URBAN DESIGN CONSULTATION RESPONSE

Design Officer	Azhar Kapadi
Date	02.08.26
Application Reference	PL/2026/0549
Address	Vacant land north of Drake Street. Site is bound to the north by St. Alban's Street, east by Broadfield Stile, and to the west by Speedwell Garage, Rochdale, OL16 1PJ
Proposal	Residential development comprising 27 affordable dwellings, including one apartment building (3 storey) containing 23 apartments and a terrace (2.5 storey) of 4 family houses, together with associated external works.

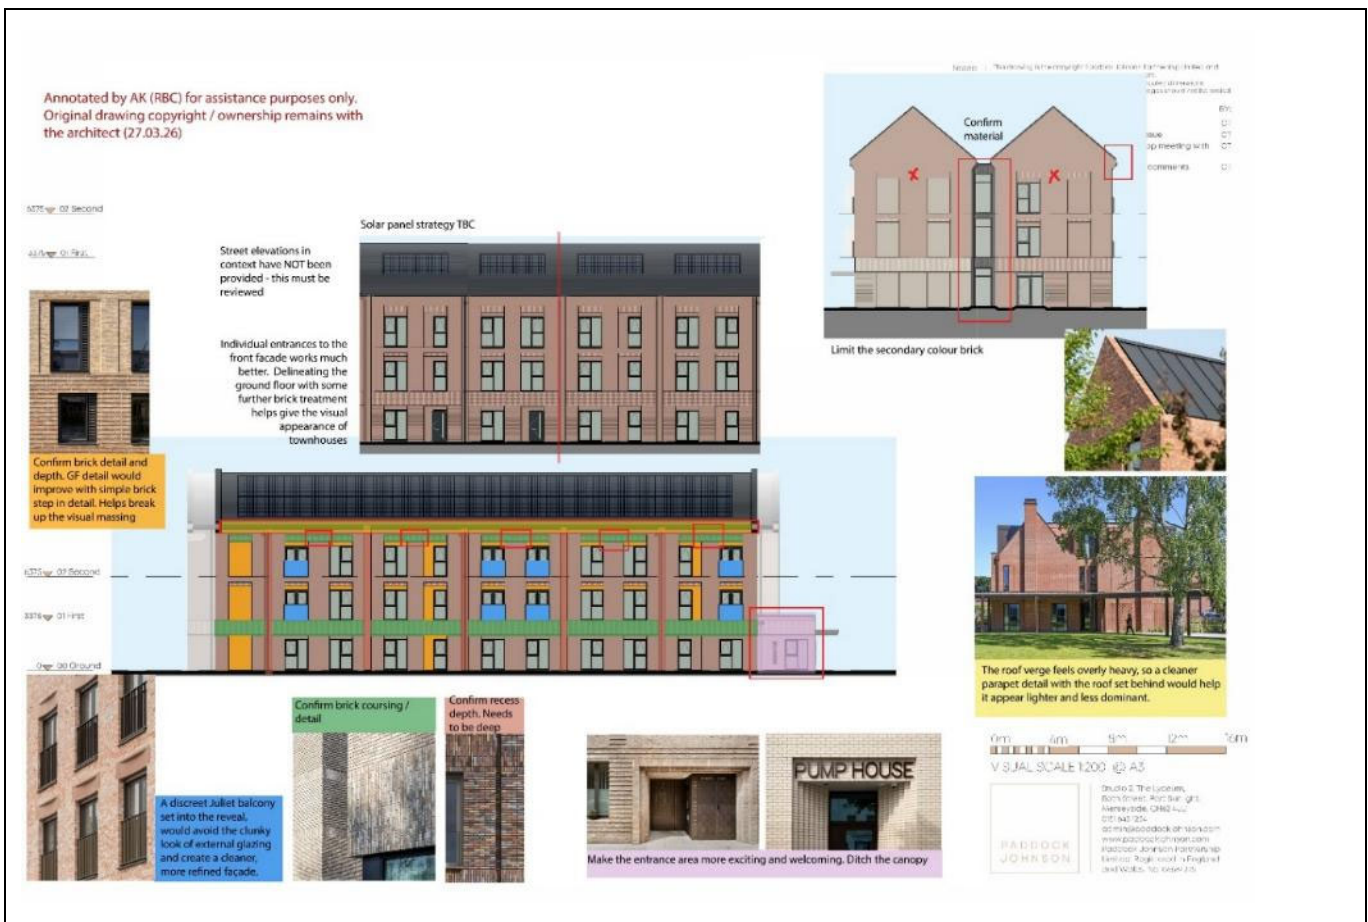
Whilst I appreciate the materials and fenestration are better in the application proposal this is an example where the transition does not work because of both the colour and the lack of articulation.

1. Strongly advise reviewing and amending colour of brickwork
2. Add additional detail to ground floor brickwork

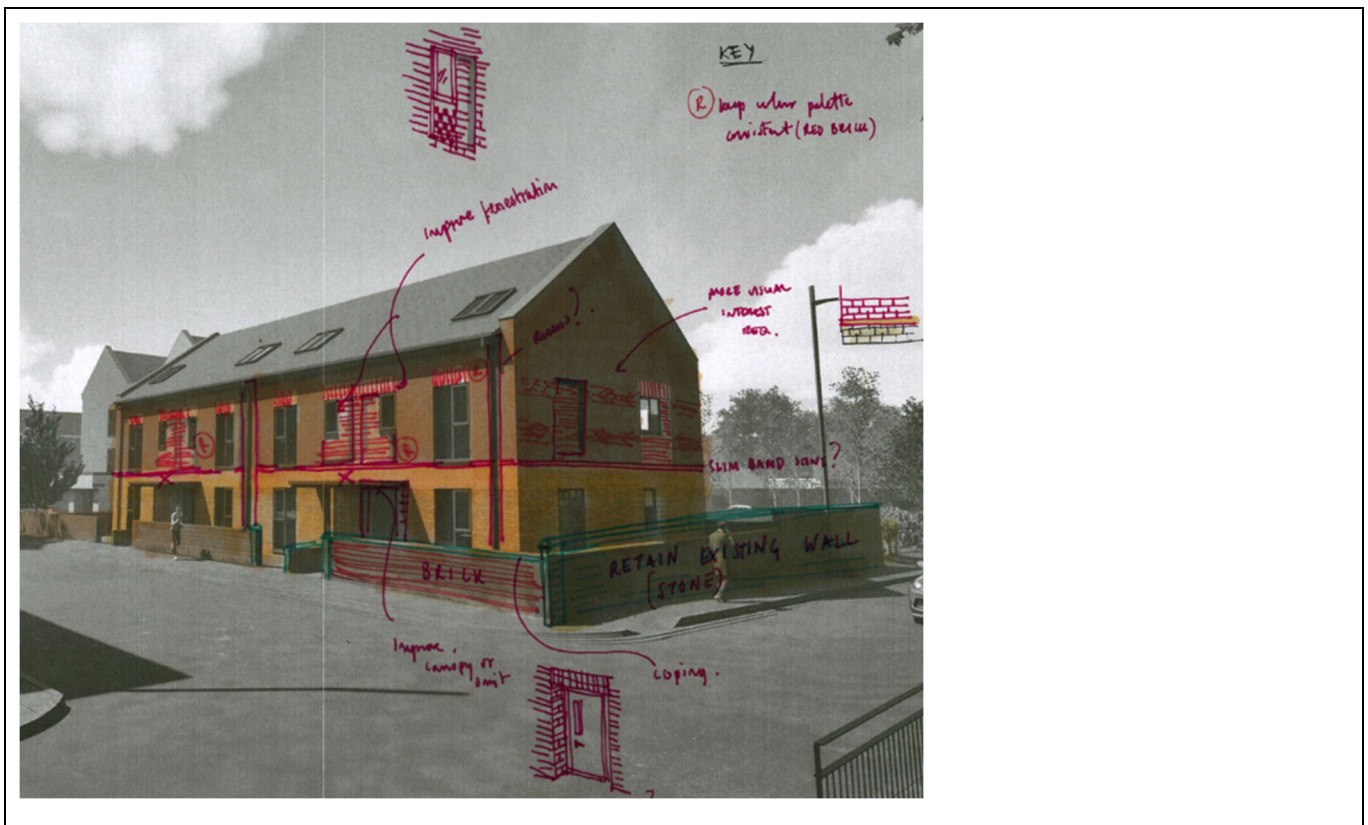
I could not find a plan defining the hard landscaping. Across the borough, we do not promote developments that are heavily dominant in tarmac. I would expect some differentiation to parking spaces and paved areas at the very least.

1. Clarify treatments to external floor finishes. Tarmac over-use is not supported.
